HIROSE ELECTRIC CO., LTD.  
5-23, OSAKI 5-CHOME, SHINAGAWA-KU, TOKYO, JAPAN

### Product Change Notification

## ■ Product List Business 430-18017\_TM21R-5C-88 Packaging Specification Change

Attachment 2 Packaging Specification After Changes

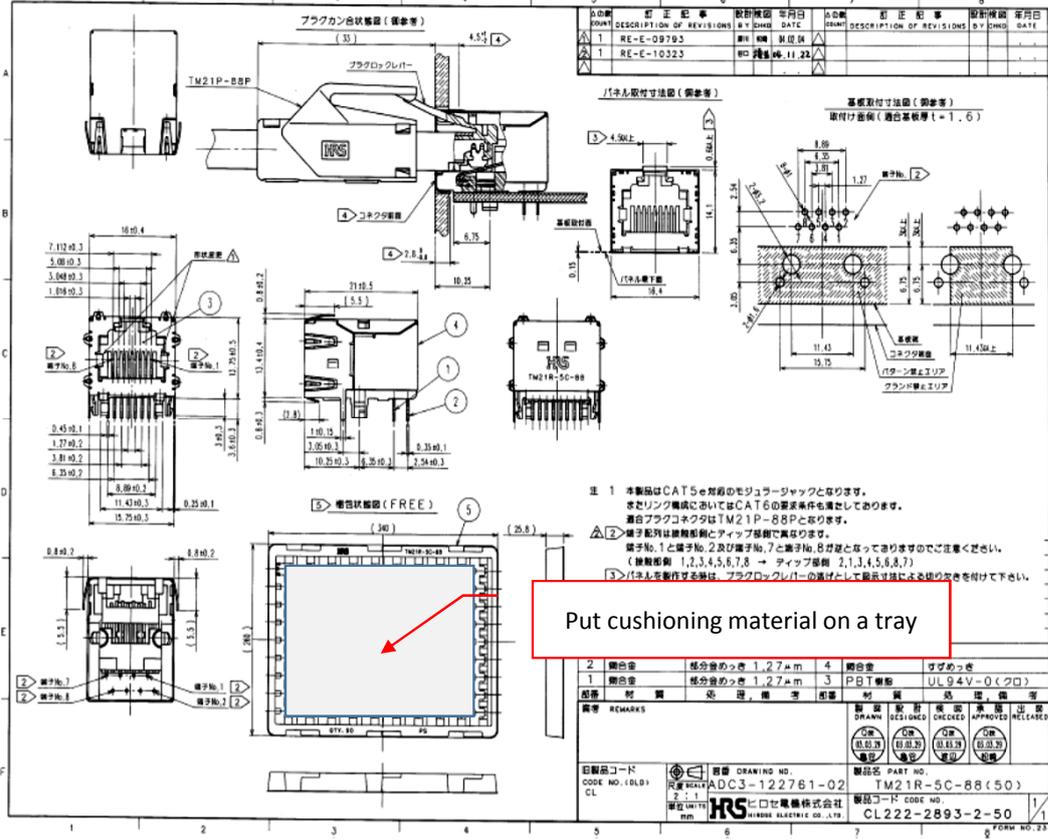
1	Products affected	Please refer to the attachment 1 (Product list).
2	Replacement product	No change in product code and product name.
3	Classification of change	Packaging specification change
4	Changes	This is to change packaging specification to put a cushioning material (Minafoam) on a tray which contains metal shell, and stack trays alternately.  Please refer to the attachment 2 for details.  This change will not affect product performances.
5	Reason for change	To prevent from rubbing and tarnishing the product surface.
6	Timing of change	July 2, 2018.
7	Date of your acknowledgement	June 29, 2018

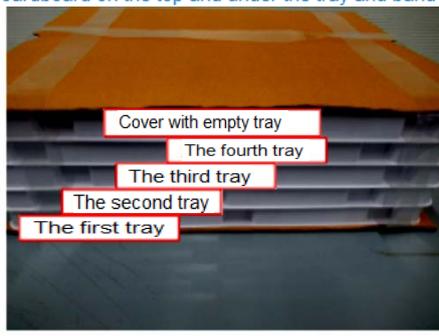
«Put cushioning material (Minafoam) on a tray after placing 90 products in a tray»

Prevent from rubbing and tarnishing the product surface.

« Stack 4 trays which contain products alternately and cover with empty tray. »  
Put cardboard on the top and under the tray and band them.

«Put the banded trays into packaging box in two layers.»
